WORK ORDER No. 1

7-106 K-7925-03

As-Needed Statewide Engineering Services

Figure 2  
K-10 Interchanges Study (K-7 and Prairie Star Parkway)

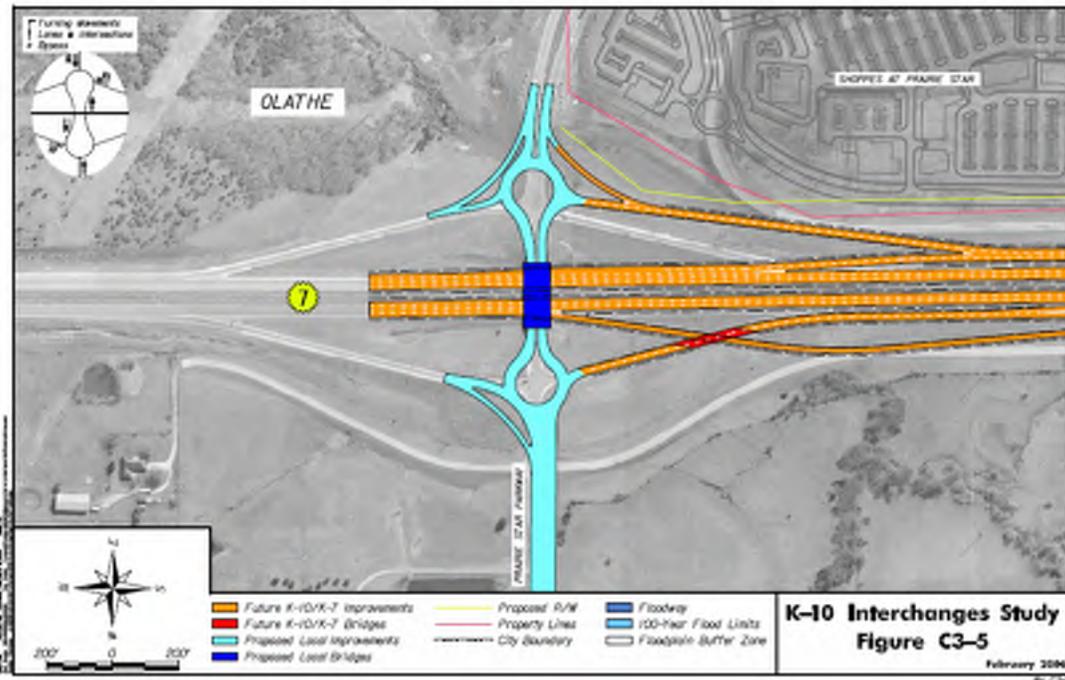
The K-10 Interchanges study developed a VISSIM operational traffic model which included the K-7 and Prairie Star Parkway Interchange. As shown in Figure 2, a 2-lane roundabout with a right turn bypass lane for the northbound ramp terminal was identified at this location. The Falls at Prairie Star Parkway traffic study identified signalized intersections at the interchange ramp terminals in the report and analyzed their impact in the report. A roundabout analysis was performed and included in the Appendix but was not identified in the report.

In conclusion, a write-up of the proposed Falls at Prairie Star development with the planned interchange roundabouts was not provided in the report. Traffic evaluation of vehicle operations and queues between the K-7 roundabout ramp terminal and Woodsonia Drive was not performed.

A system's analysis approach would provide a comprehensive understanding of cumulative impacts around the interchange and along Prairie Star Parkway to Woodsonia Drive. This type of analysis would also provide an arterial level of service on Prairie Star Parkway. This would provide a more comprehensive understanding of future K-7 and Prairie Star Parkway system improvements. This analysis could be provided with the current Synchro model developed for the project using SimTraffic simulation software.
